ISSUE DATE: 06-30-2023	REVISION COMMENTS
DATE	
07-18-2023	CITY DRC COMMENTS

AVILLA RAILHEAD PROPOSED SITE PLAN

AVILLA RAILHEAD - (2940-2302)

ISSUED FOR: PERMIT

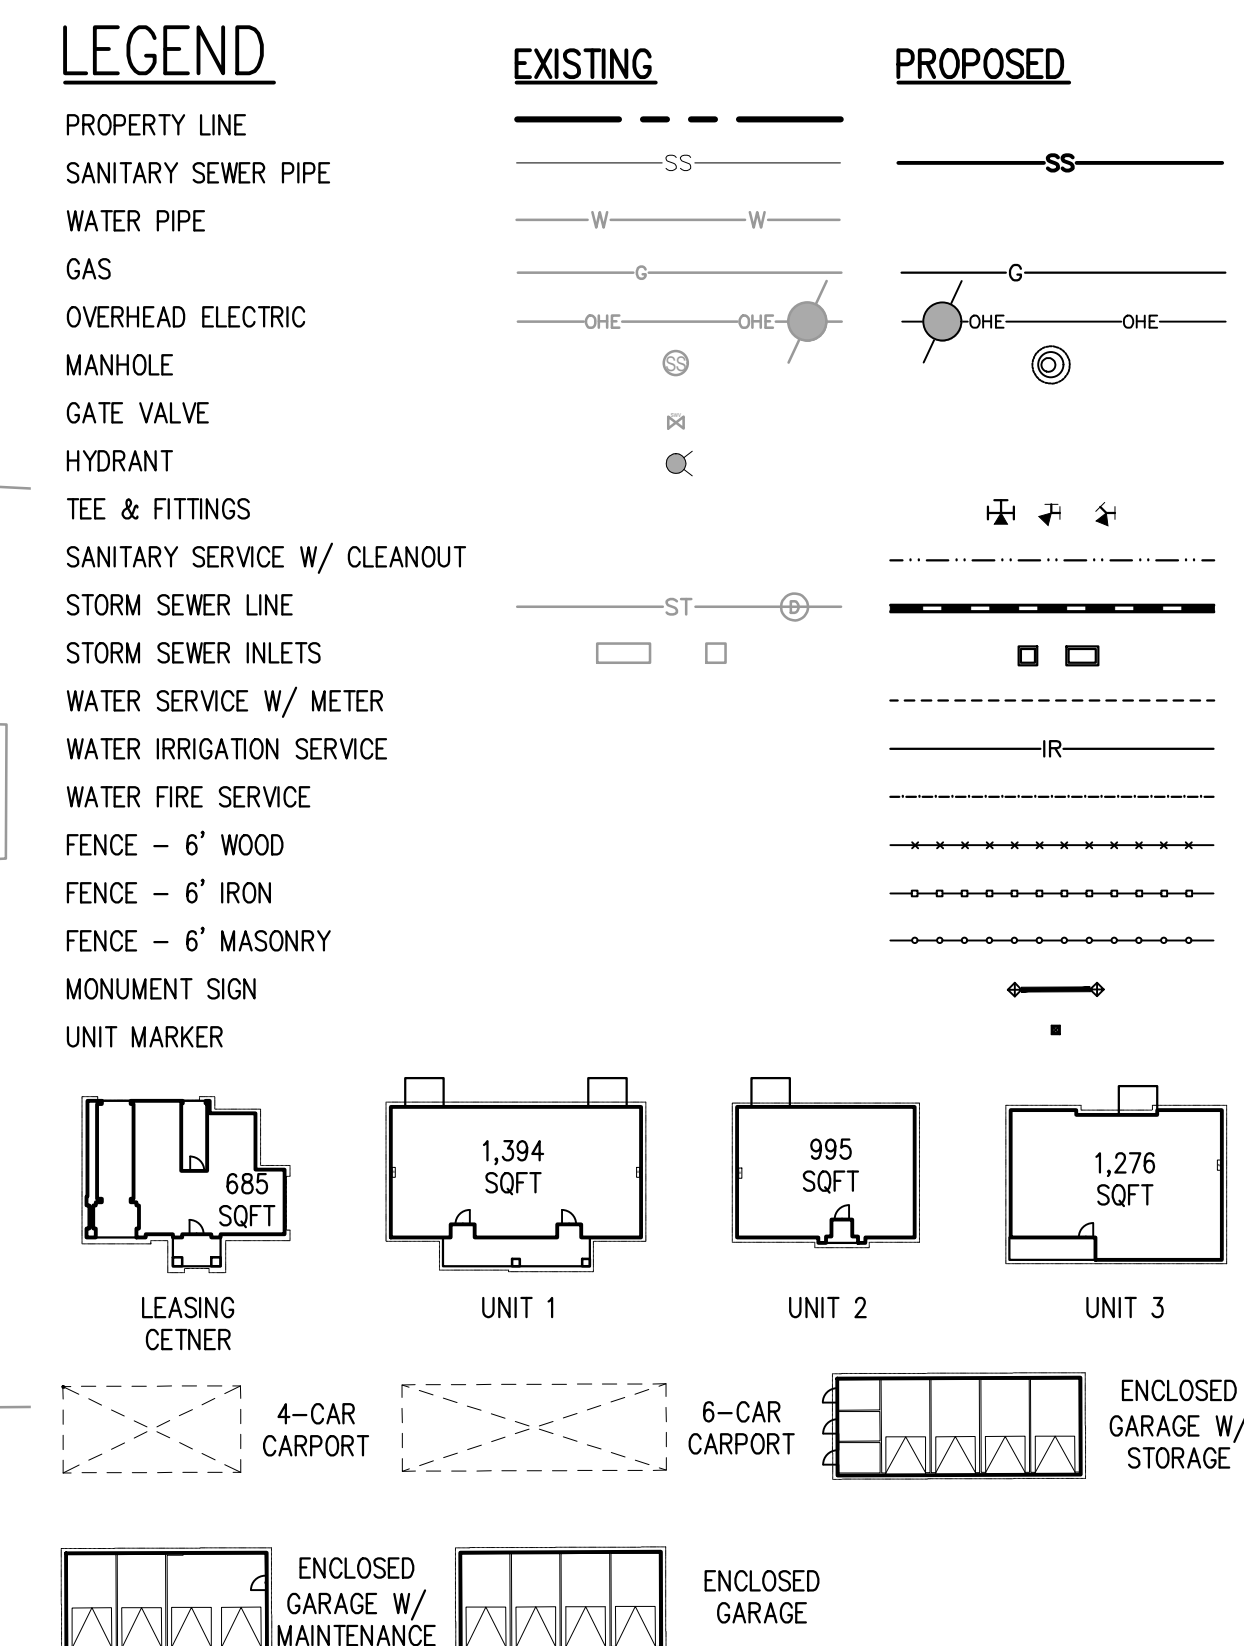
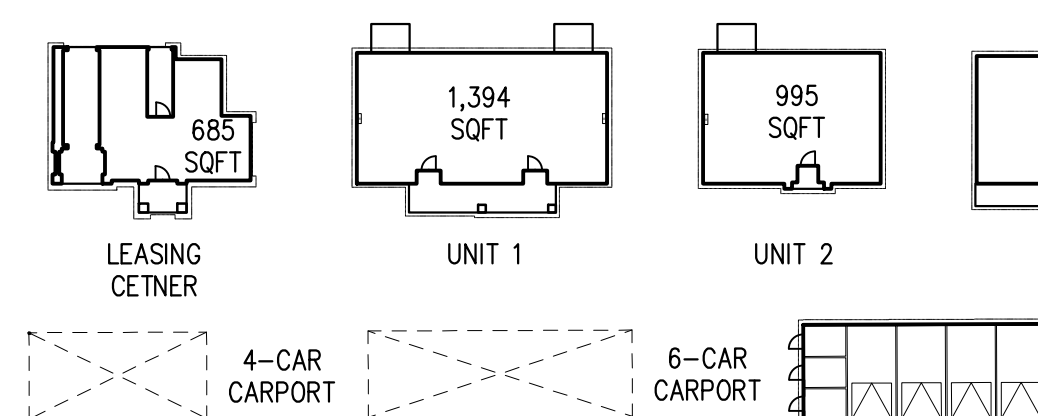
Relocate the label to point to the proposed fence.

Informational comment: A sign permit is required for all signs.

Add the end parenthesis

1 space
